SUBJECT: AMENDMENT NO. 42 TO FACILITY OPERATING LICENSE NO. NPF-58 (TAC NO. M79366)

PERRY NUCLEAR POWER PLANT, UNIT NO. 1

Amendment No. 42
License No. NPF-58

ATTACHMENT TO LICENSE AMENDMENT NO. 42

REACTOR VESSEL WATER LEVEL
Bases Figure B 3/4 3-1

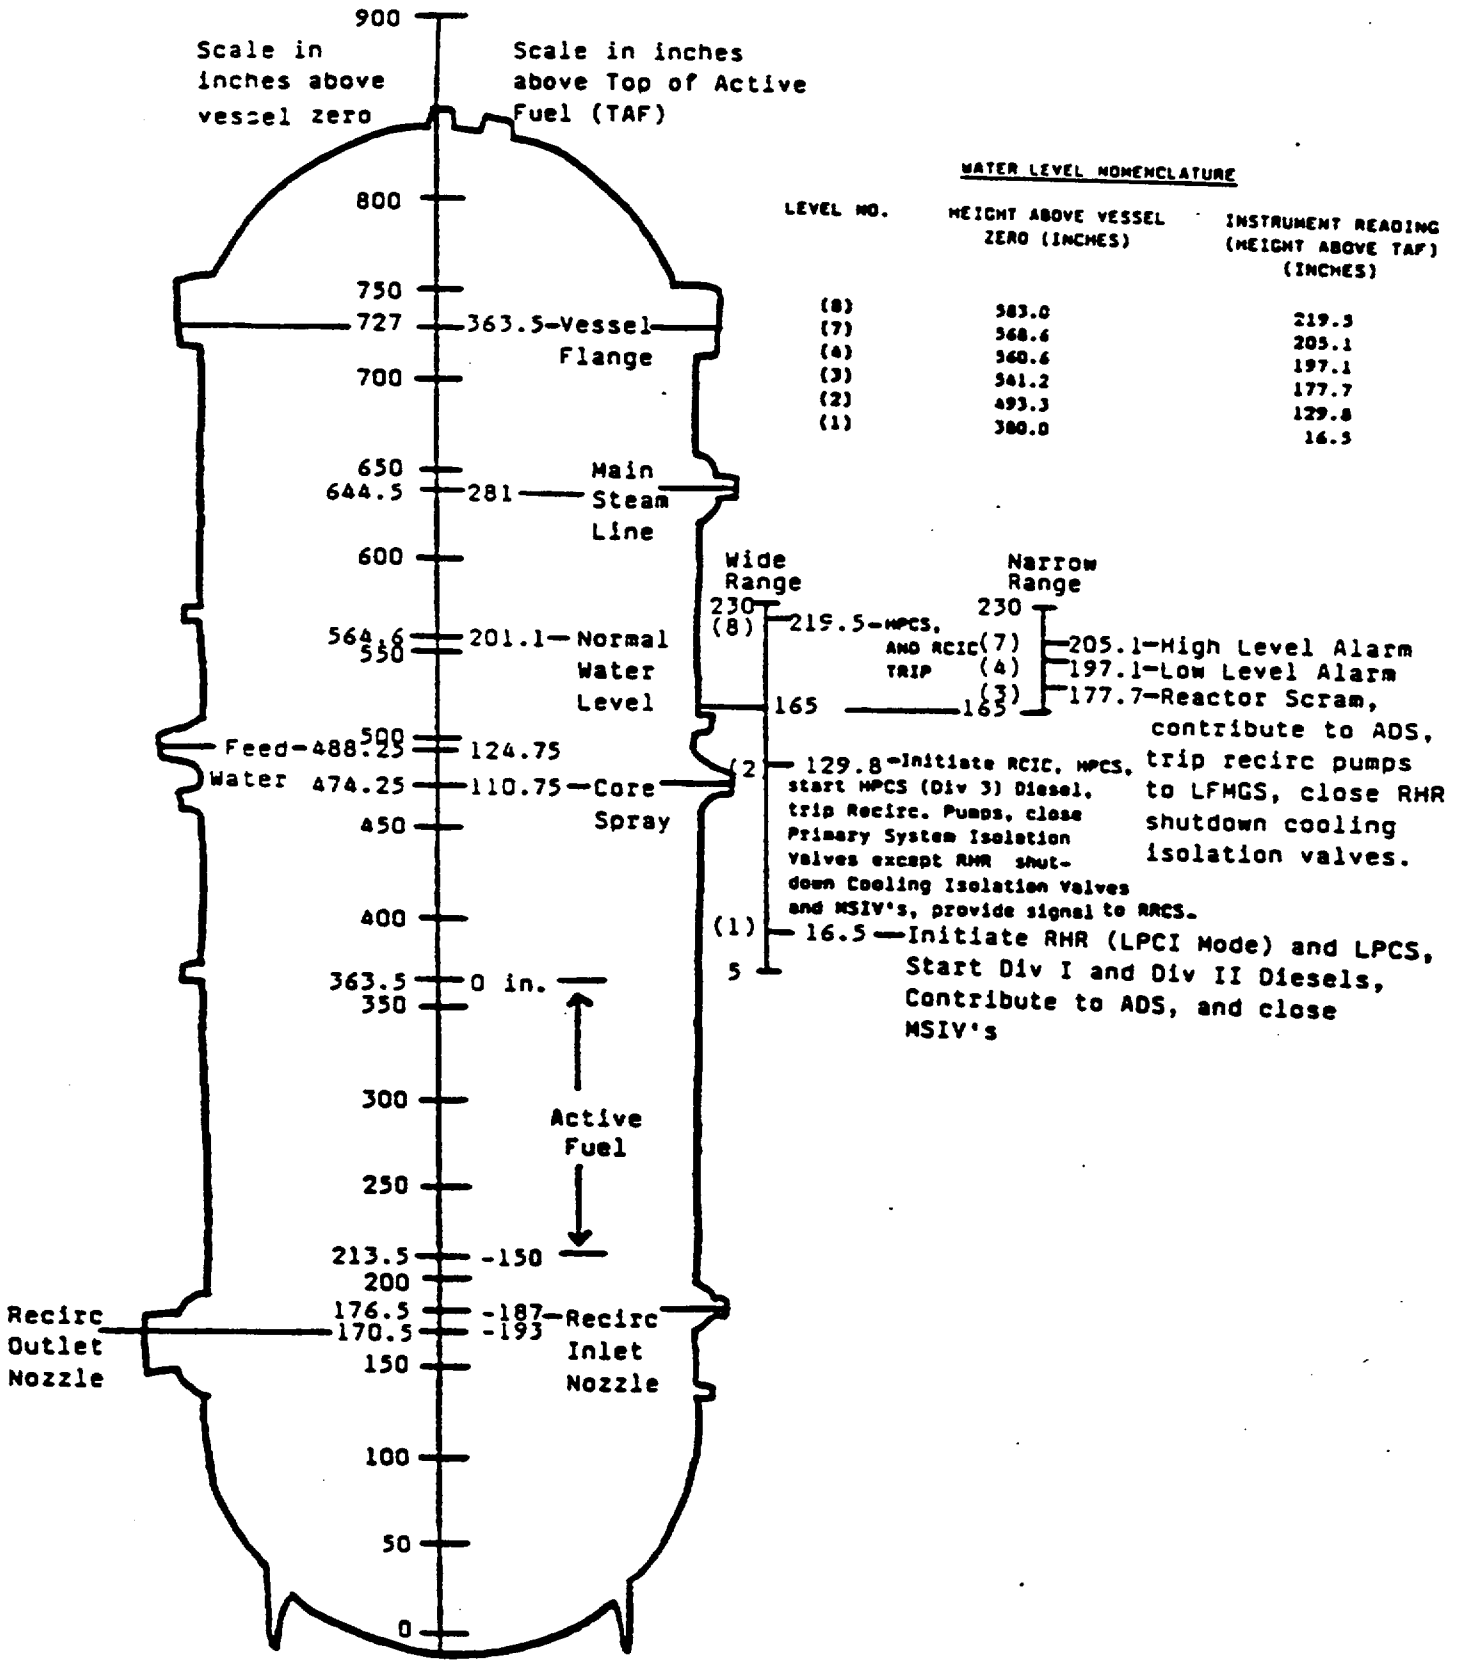
The above changes to Bases page B 3/4 3-5 are purely administrative changes designed to achieve consistency and correct errors. For clarification, Bases Figure B 3/4 3-1 on page B 3/4 3-8 is to be replaced.
